GE Hitachi Nuclear Energy

MFN 15-069

Subject: **GEH Proposed Resolution of Item # 26 - Fukushima Recommendation 4.2
Mitigation Strategies of NRC Suggested U.S. Advanced Boiling Water Reactor
Design Changes**

**GEH Response to Item #26 - Fukushima Recommendation 4.2
Mitigation Strategies**

Figure 2.4.1b Residual Heat Removal System (RHR-B)

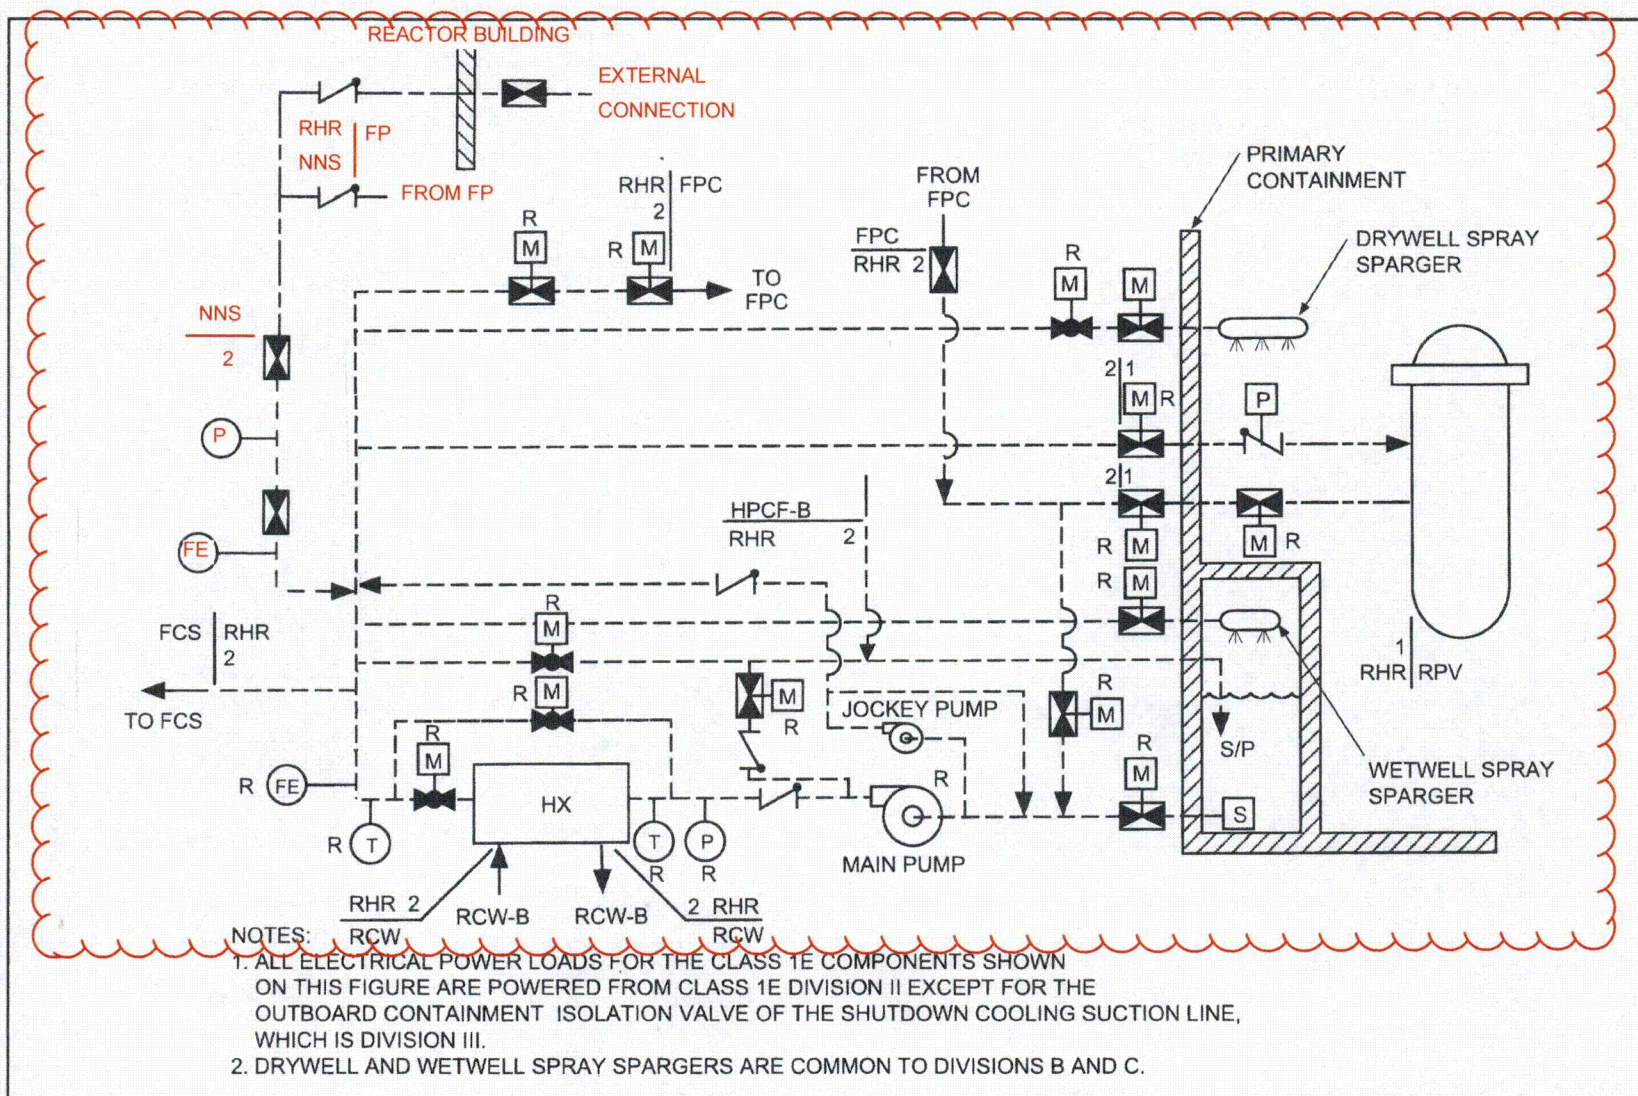
ABWR DCD rev 5, Tier 1, Figure 2.4.1.b Residual Heat Removal System (RHR-B) will be updated to show the new AC independent water addition piping, valves, and connections for Loop B.

FIGURE 5.4-10 RESIDUAL HEAT REMOVAL SYSTEM P&ID (Sheet 5 of 7)
ABWR DCD/Tier 2 Rev. 5 25A5675BC 21-107

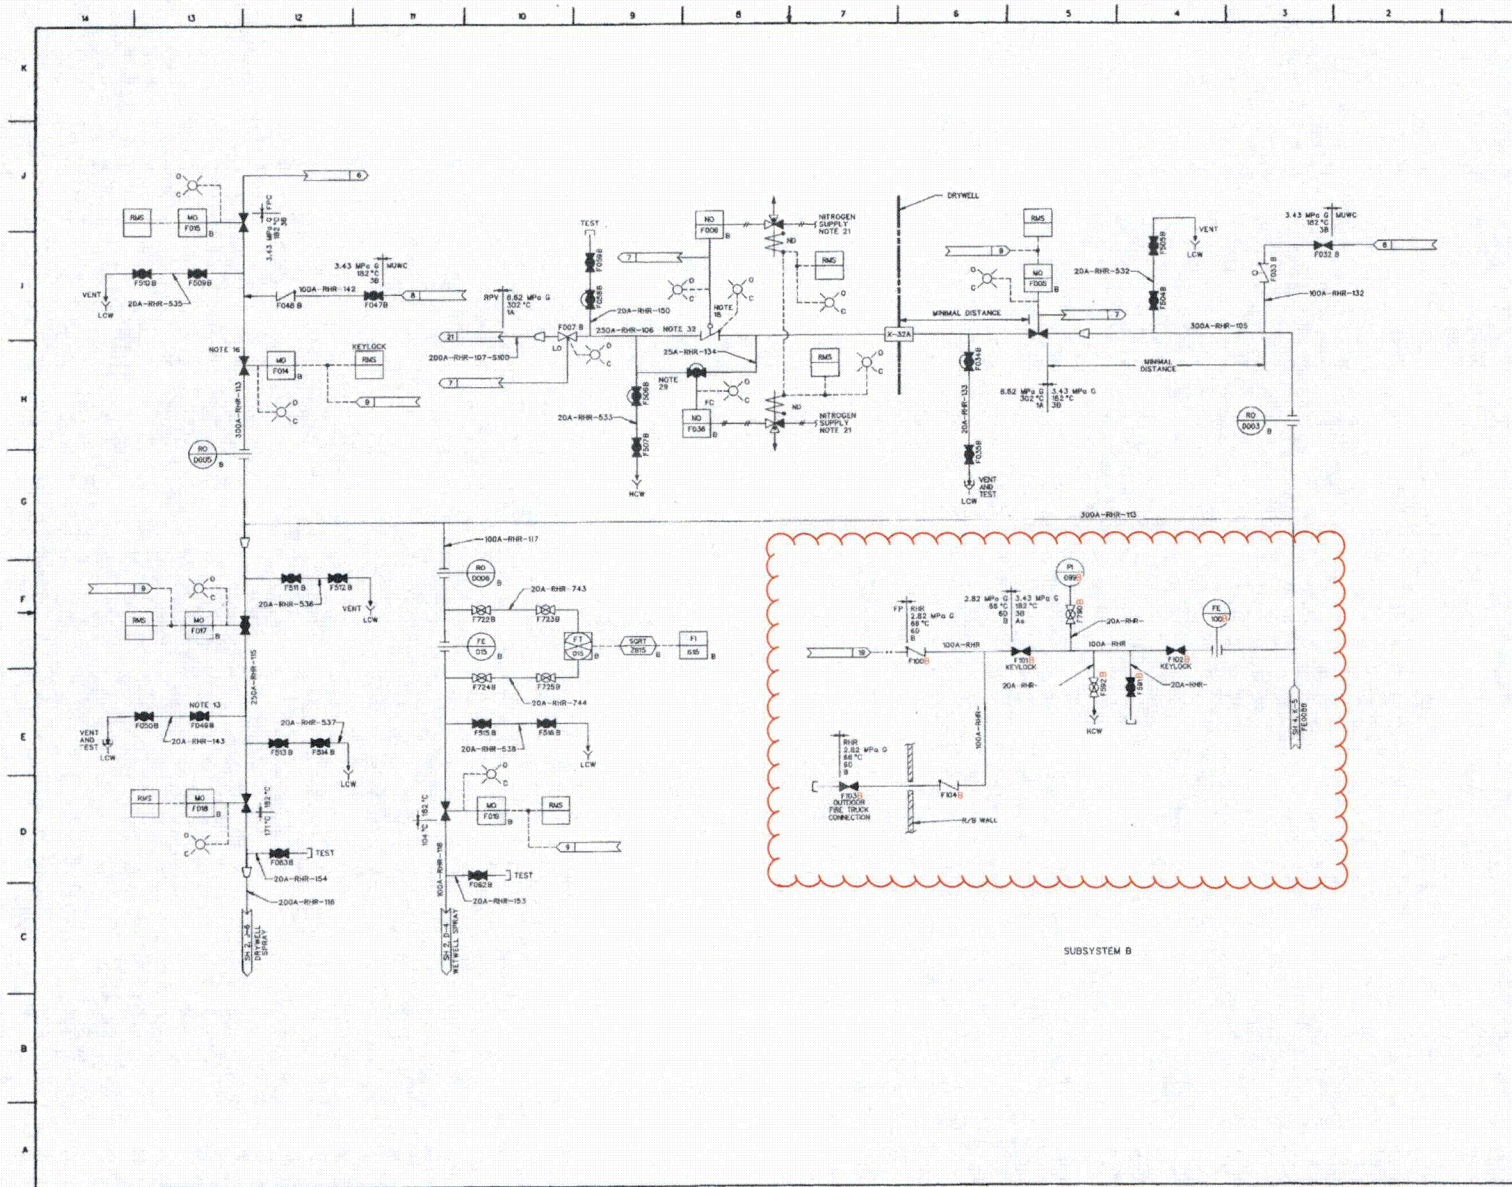
ABWR DCD rev 5, Tier 2, Figure 5.4-10 Residual Heat Removal System P&ID (Sheet 5 of 7) will be updated to show the new AC independent water addition piping, valves, and connections for Loop B.

Figure 5.4-10 shows the connections from either the diesel-driven pump or the fire truck to RHR system loops B and C. The connections to the diesel-driven pump (FPS) are adjacent to the RHR valve rooms. Opening valves F101B/C and F102B/C allows water to flow from the FPS into the RHR piping. Periodic stroke testing of these valves is required by Table 3.9-8 to ensure valve operability. The fire truck connections are located outside the reactor building at grade level, on different faces of the building. Both connections to the RHR system are protected by a check valve (F100B/C and F104B/C for the diesel-driven pump and the fire truck, respectively) to insure that RCS pressurization does not result in a breach of the injection path. Detailed procedures for the operation of the ACIWA, including operation of the FPS valve in the yard, are required to be developed by the COL applicant. See Section 19.9.7.

Figure 2.12.1 Class 1E Electrical Power Distribution System

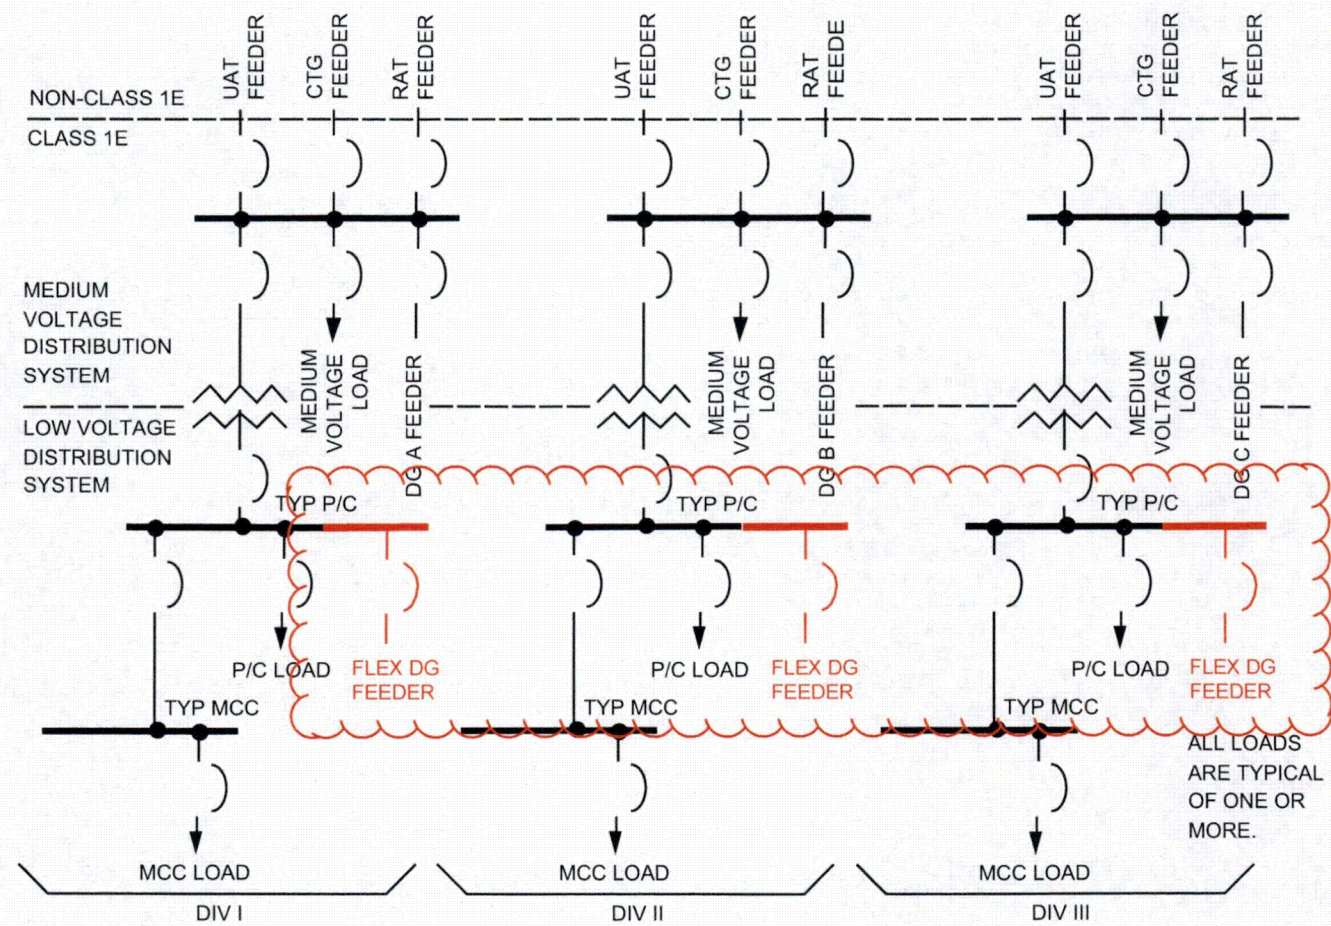
ABWR DCD rev 5, Tier 1, Figure 2.12.1 will be updated to show the FLEX diesel generator tie-in points to the 1E divisional power centers.

External (to Reactor Building) connections are provided to all three 1E Reactor Building 480 VAC Power Centers for portable FLEX diesel generators. The connectors are isolated from the Power Centers by normally open 1E breakers.

FIGURE 8.3-1 ELECTRICAL POWER DISTRIBUTION SYSTEM SLD (Sheet 3 of 3)
ABWR DCD/Tier 2 Rev. 5 25A5675BH

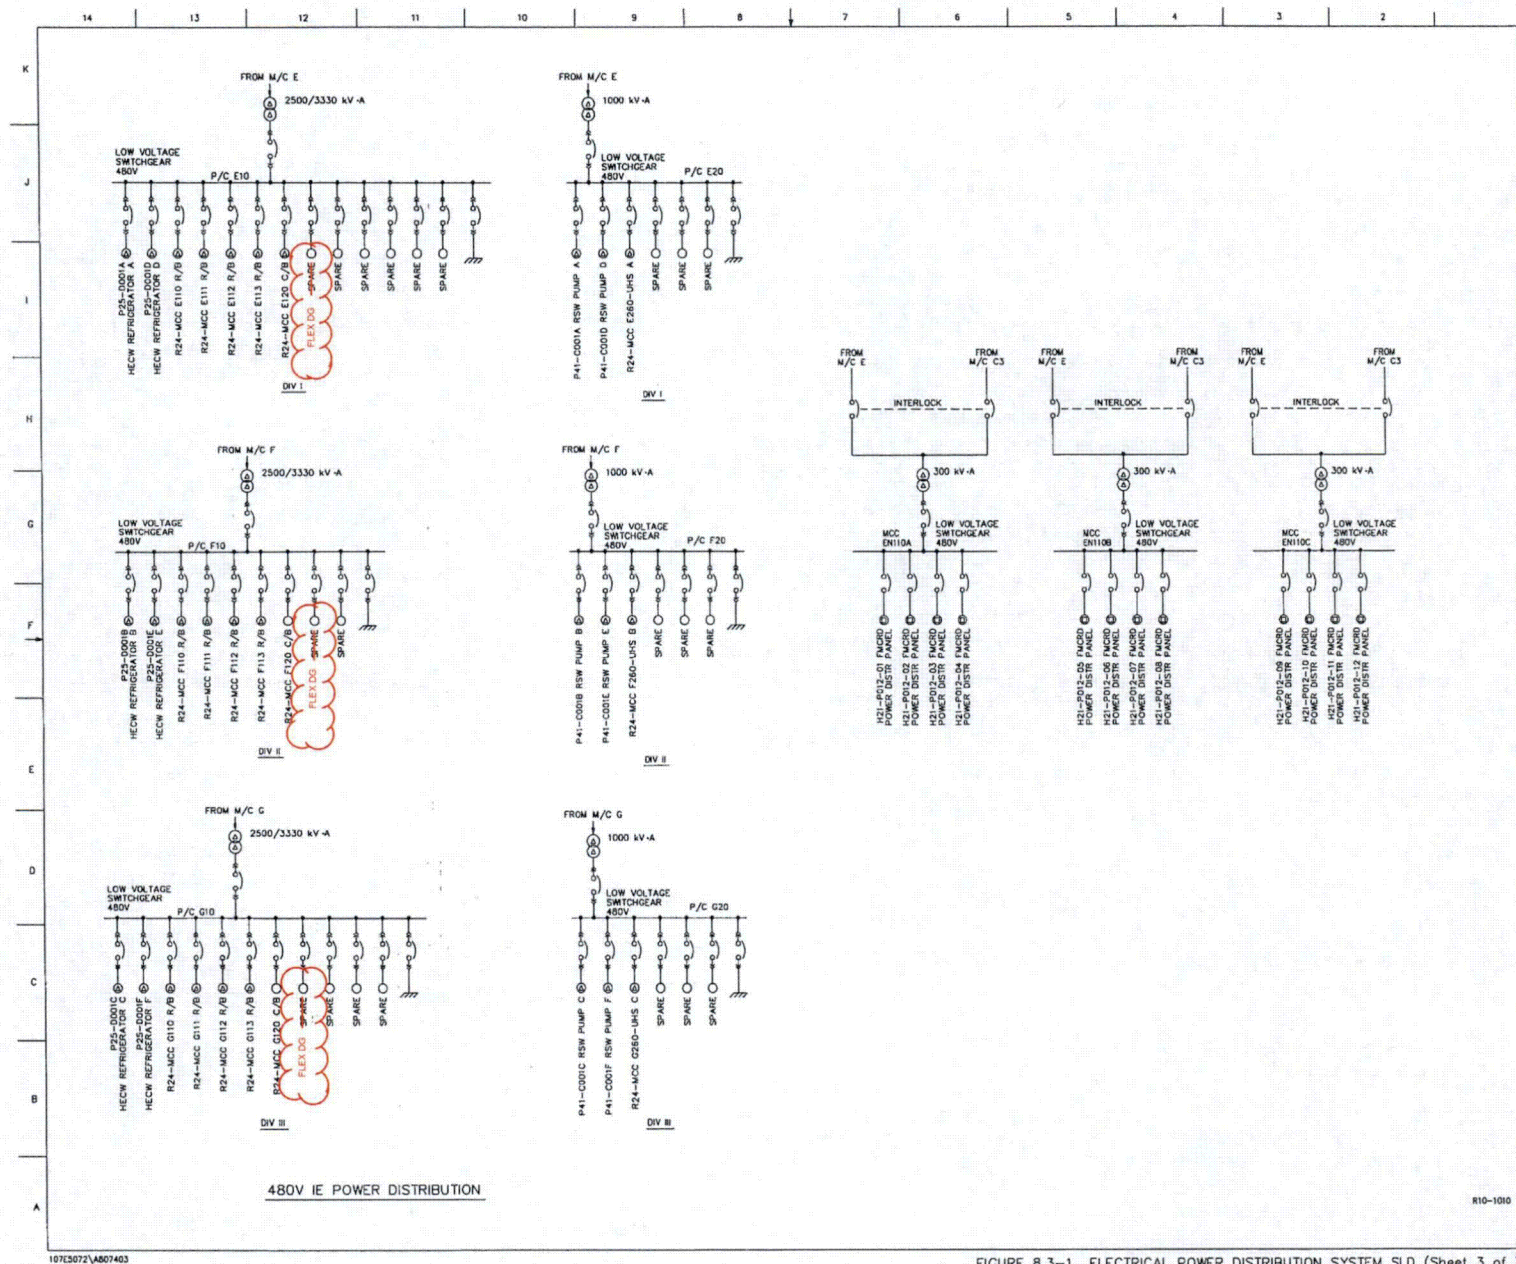
ABWR DCD rev 5, Tier 2, Figure 8.3-1 Sheet 3 will be updated to show the FLEX diesel generator tie-in points to the 1E divisional power centers.
